Potential Impact of New Urban Development on Flooding on James Island, Charleston, South Carolina

Steven H. Emerman, Ph.D., Malach Consulting, LLC, 785 N 200 W, Spanish Fork, Utah 84660, USA, Tel: 1-801-921-1228, E-mail: SHEmerman@gmail.com

Report written for South Carolina Coastal Conservation League, submitted July 9, 2020

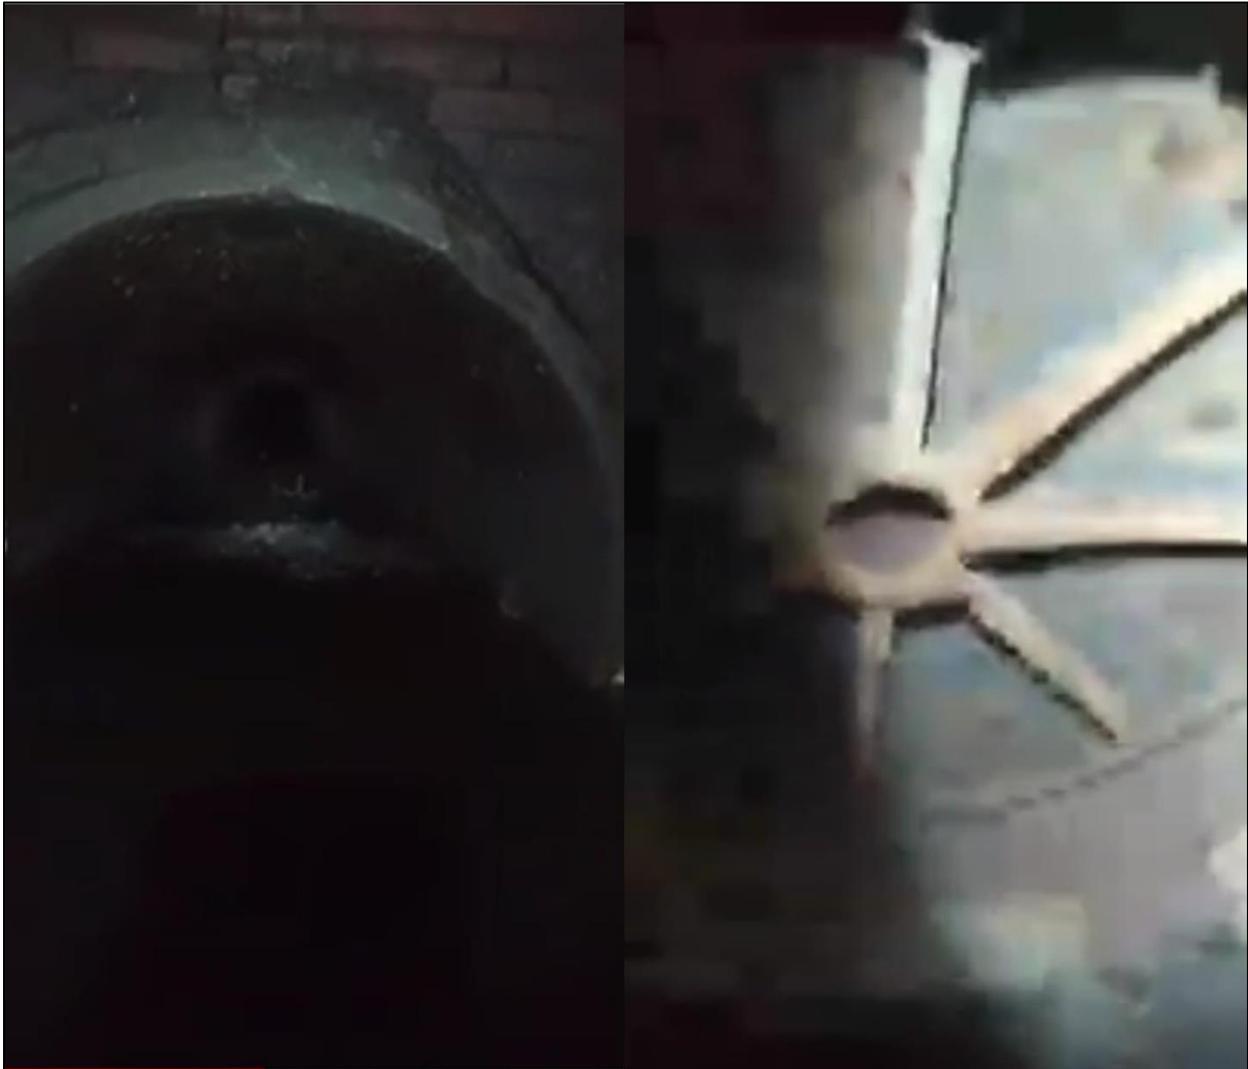
woody debris, and trash, such as abandoned shopping carts (see Fig. 3, 7a-c). At one site, two parallel subsurface stormwater pipes were located with diameters of 42 and 48 inches (see Fig. 8a). The 42-inch pipe was completely blocked and was about half-full of standing water (see left-hand side of Fig. 8a). The blocked pipe was immediately below a manhole cover, which could have facilitated inspection and maintenance (see right-hand side of Fig. 8a). At the downstream end where the stormwater pipes emerged at the surface and flowed to James Island Creek, the 48-inch pipe was observed to be open at both ends (see Fig. 3 and right-hand side of Fig. 8b). However, the 42-inch pipe was completely blocked with large rocks on the downstream side (see left-hand side of Fig. 8b).

According to the Department of Stormwater Management, the blocked pipe (see Figs. 8a-b) was an intentional alteration of the stormwater infrastructure, not a lack of maintenance. The City of Charleston (2020a) responded to local residents, “It does look like the 42” pipe was actually sealed shut a number of years ago rather than it being clogged.” However, the Department of Stormwater Management had no records of such an alteration. In a follow-up message, City of Charleston (2020b) wrote, “From the records of the work we did to rehabilitate this system in 2016 it looks like the pipe must have been closed off before that. As a result, it would have been done before most of us working in stormwater engineering at the City and County were here. We are looking into if we have any records of what might have happened on this system or if any of the longer tenured maintenance employees have any knowledge on this and will let you know if we find anything out.” There was no follow-up on the preceding message, so that, presumably, neither written nor mental records were located.

Within the same communications to local residents, the Department of Stormwater Management said that it was irrelevant for stormwater modeling whether that particular 42-inch stormwater pipe was or was not blocked. According to City of Charleston (2020a), “We did have AECOM evaluate upsizing or reconstructing this pipe [the blocked 42-inch pipe] in our current

model to determine if it has any benefit on reducing flooding. The drainage model shows that there are a number of upstream constrictions that also need to be improved before upsizing this pipe would reduce flooding in the area. For example, the pipes under Central Park Road are a 42” pipe and a 36” pipe [see clogged stormwater ditches leading to the 36-inch and 42-inch pipes in Fig. 7a], and between Central Park and this drainage box are another pair of 42” pipes, all of which already have less capacity than this downstream 48” pipe.” The Department of Stormwater Management considered the impact on stormwater modeling of altering only a single downstream component of the stormwater infrastructure. However, that single altered component was found through a fairly cursory survey of the visible infrastructure over a small area. This raises the possibility that there could be numerous alterations of the stormwater infrastructure for which the Department of Stormwater Management has no records, and there is no way to assess the impact on stormwater modeling of these unknown alterations.

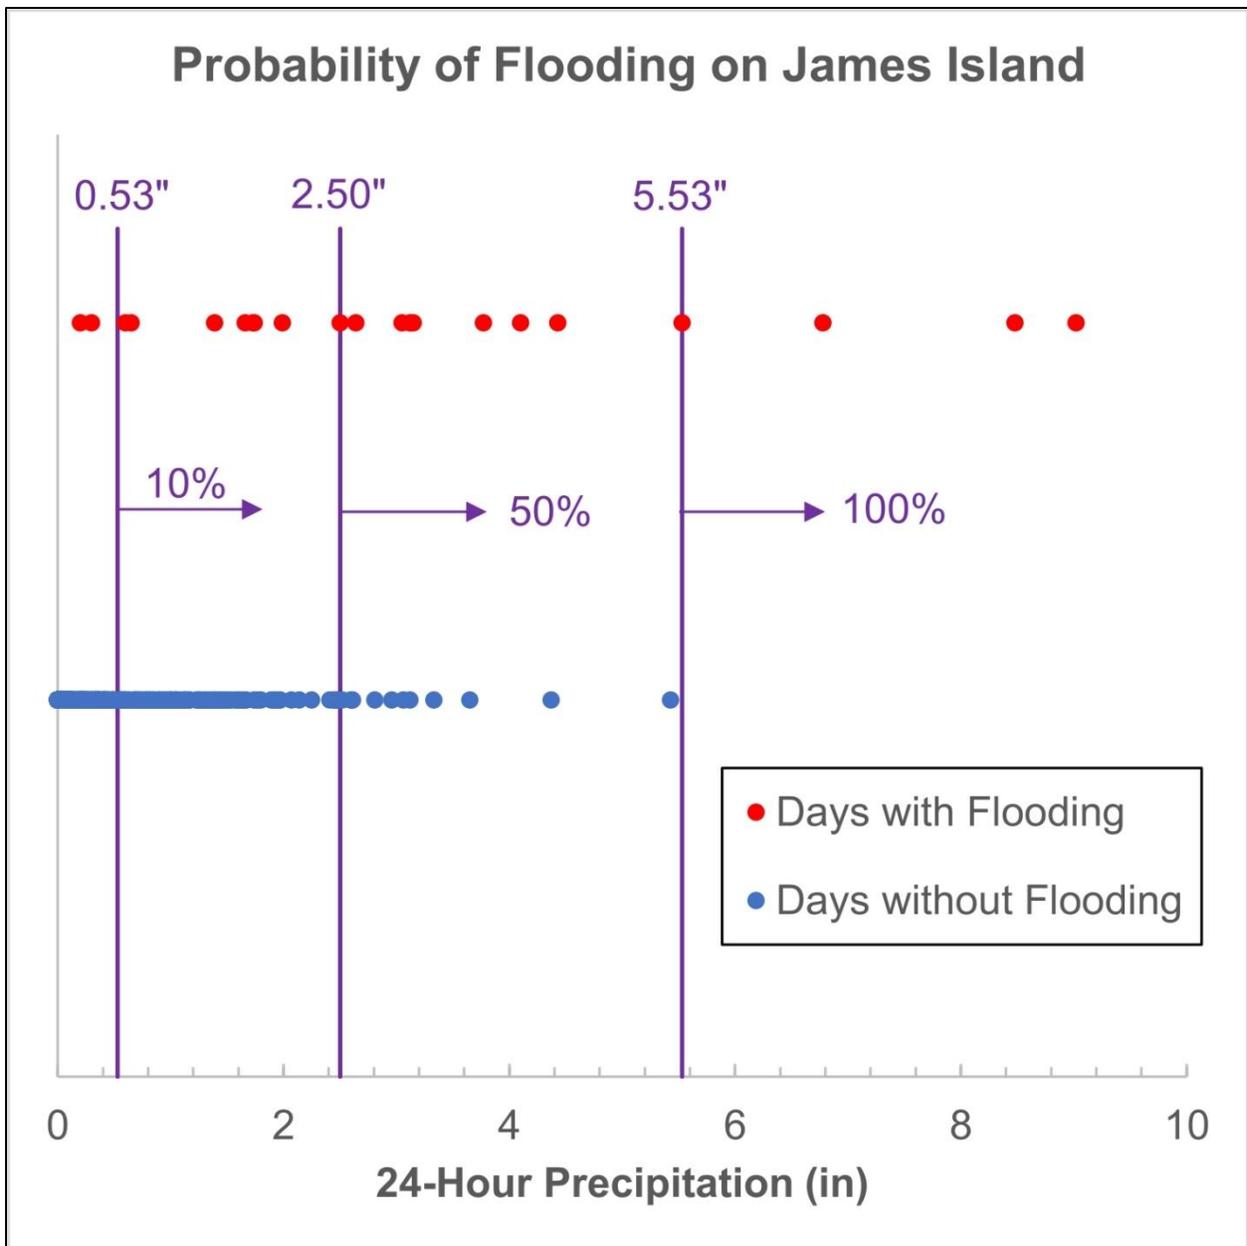
The probability of flooding on James Island was 10%, 50% and 100%, if the daily precipitation equaled or exceeded 0.53 inches, 2.50 inches and 5.53 inches, respectively (see Fig. 9a). In other words, flooding was inevitable if daily precipitation equaled or exceeded 5.53 inches and was expected if daily precipitation equaled or exceeded 2.50 inches. Moreover,

stormwater infrastructure could not be relied upon to prevent flooding if the daily precipitation equaled or exceeded only 0.53 inches. In terms of the storm return period, the probability of flooding on James Island was 59% and 100% if the daily precipitation equaled or exceeded 1.0 and 4.9 years, respectively (see Fig. 9b). In other words, flooding is inevitable for a 5-year storm and is expected for a 1-year storm. In summary, the current stormwater infrastructure does not even have the capacity to accommodate a 1-year storm (which has a 100% probability of exceedance in any given year).

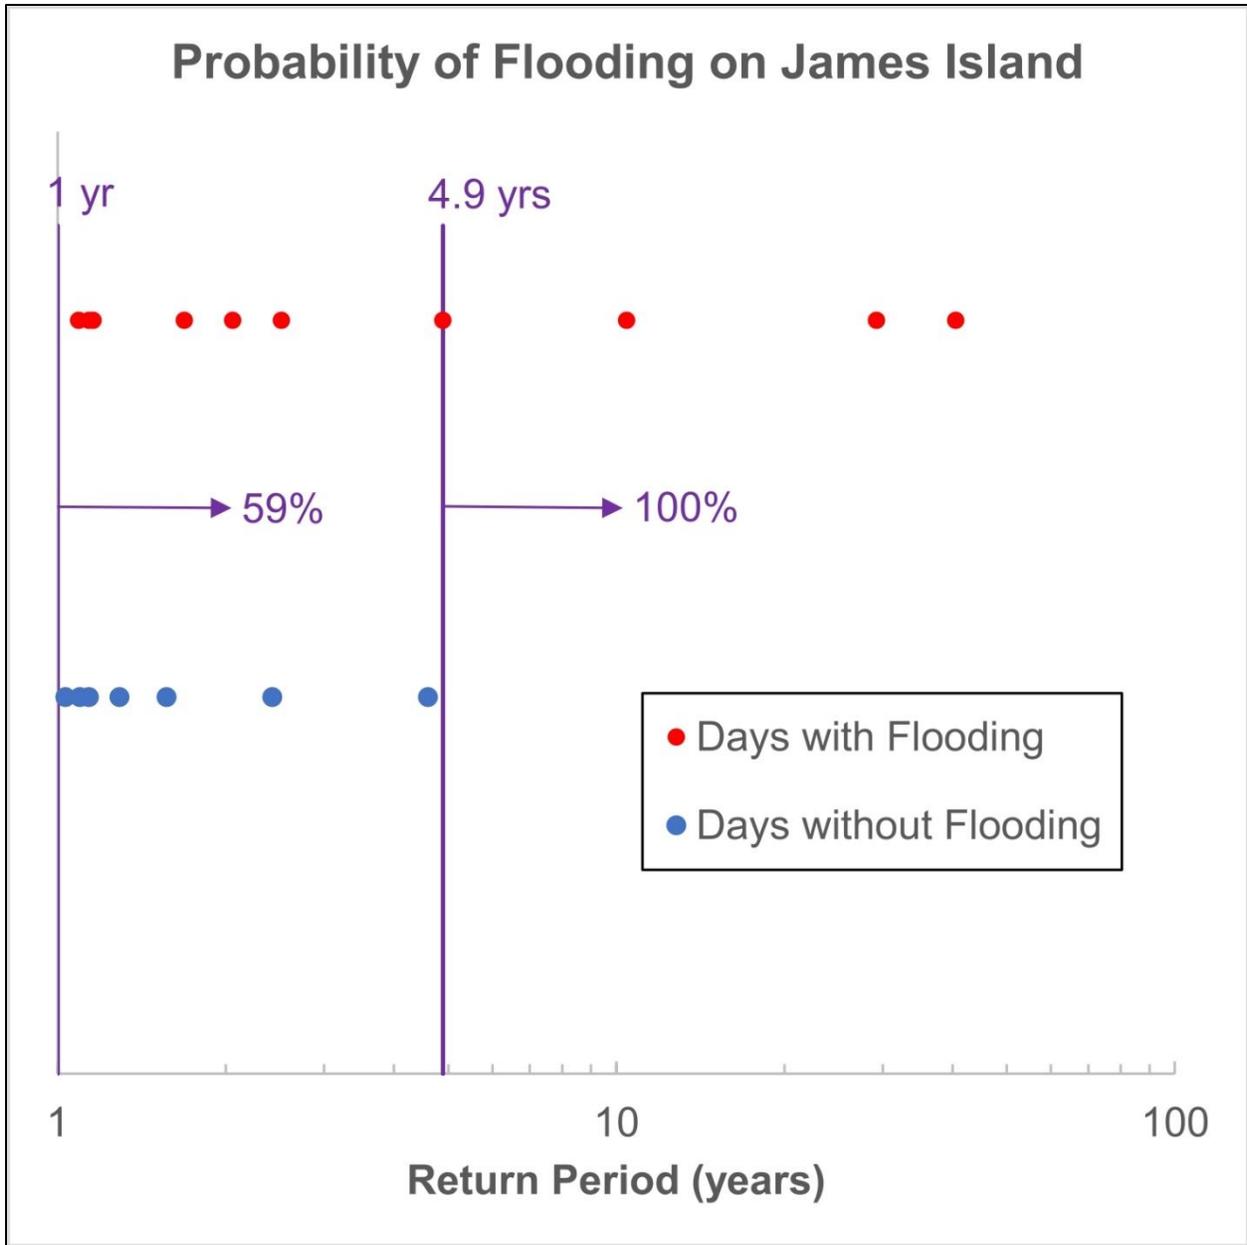
- 4) A comparison with local precipitation-frequency statistics showed that the probability of flooding is 59% and 100% for 24-hour precipitations with return periods equal to or exceeding 1 year and 4.9 years, respectively.

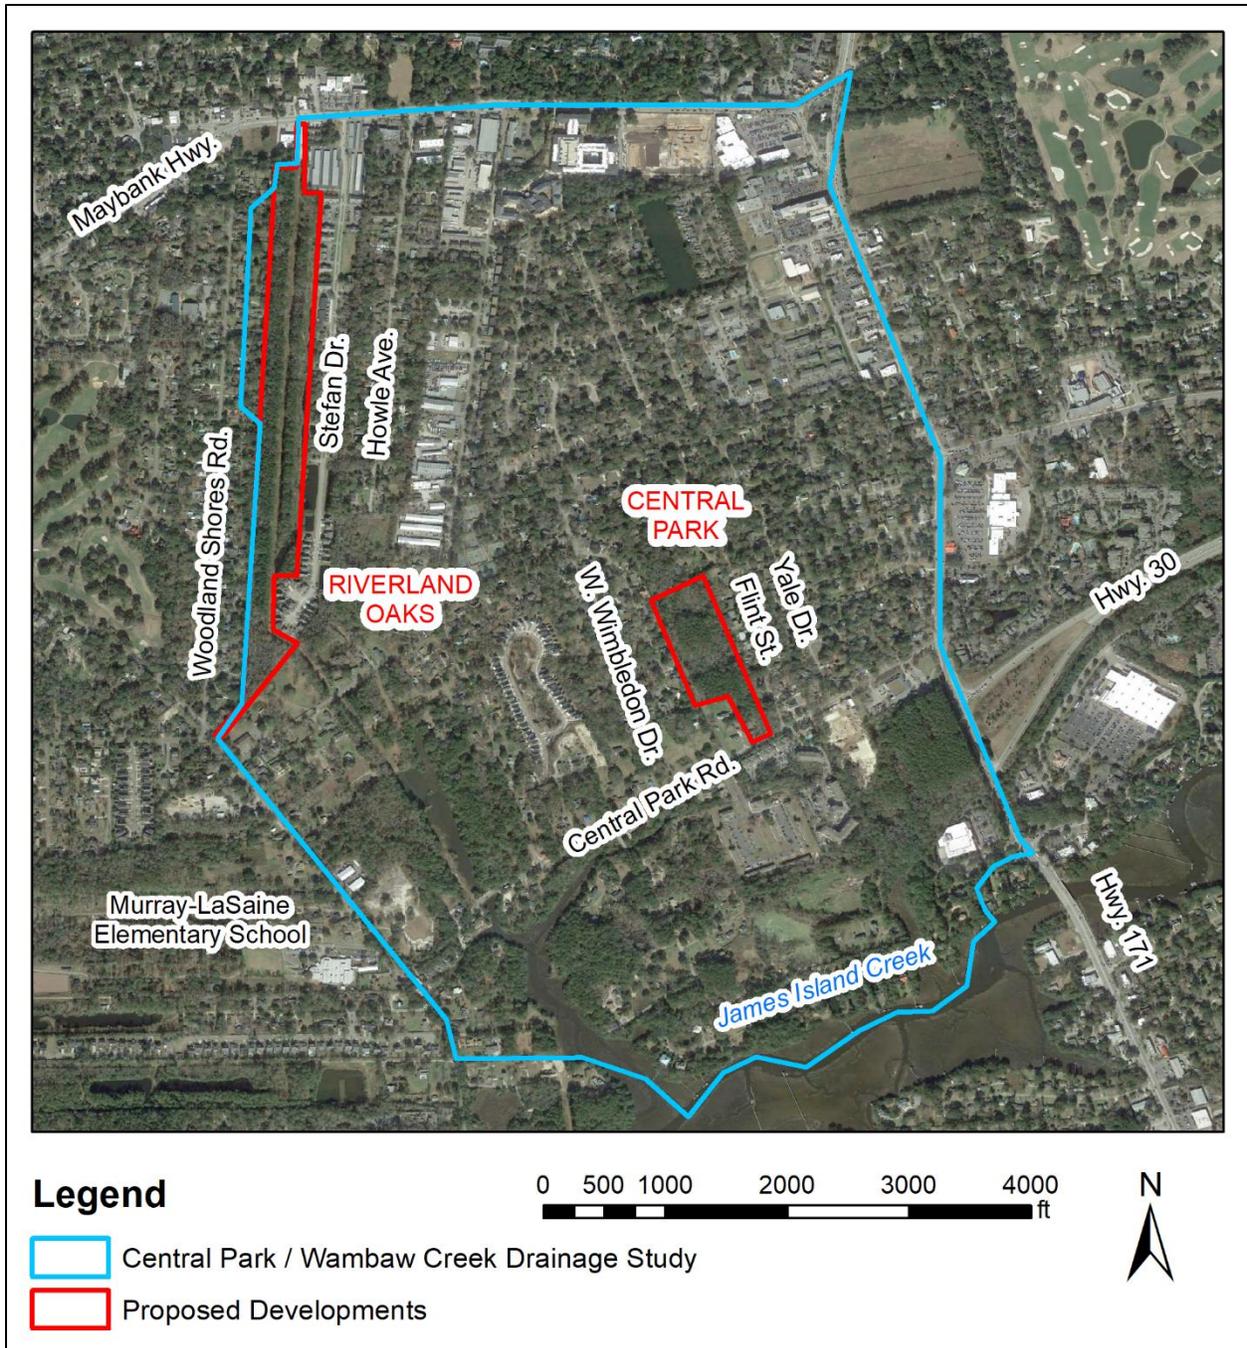
The irony of this entire discussion is that the City and County of Charleston have been carrying out a drainage study in the Central Park / Wambaw Creek watershed, at an estimated cost of \$400,000, in the exact area of the proposed Central Park and Riverland Oaks developments (see Fig. 32), since 2019 and are scheduled to complete the study in 2020 or 2021 (City of Charleston, 2020c). According to City of Charleston (2020c), “The City and Charleston County are partnering on this project to inventory all the drainage features of this basin, create a model, and recommend any maintenance and infrastructure improvements. A basin-wide stormwater drainage model is needed to determine level of service for and condition of the existing system as well as the ability to assess the impacts of development on the existing system. Suggested possible drainage improvements as well as design recommendations and standards for future development within the watershed will be included in the final plan.”

Any reasonable person would see something wrong with making decisions regarding stormwater permits in advance of completion of a study that would provide a rational basis for making a decision about the permits. It would not be enough to simply complete the drainage study before making a decision about stormwater permits. It should be necessary to consider the recommendations of the study, implement the recommendations as appropriate, and then evaluate the impact of the recommendations, in terms of their ability to reduce flooding. In accordance with the Cautionary Principle, about three to five years should be necessary to determine whether the implementation of the recommendations has, in fact, reduced flooding in the vicinity of the proposed Central Park and Riverland Oaks developments.

No new developments in the Central Park / Wambaw Creek watershed should be considered prior to implementation and evaluation of the recommendations of the ongoing drainage study of the Central Park / Wambaw Creek watershed.
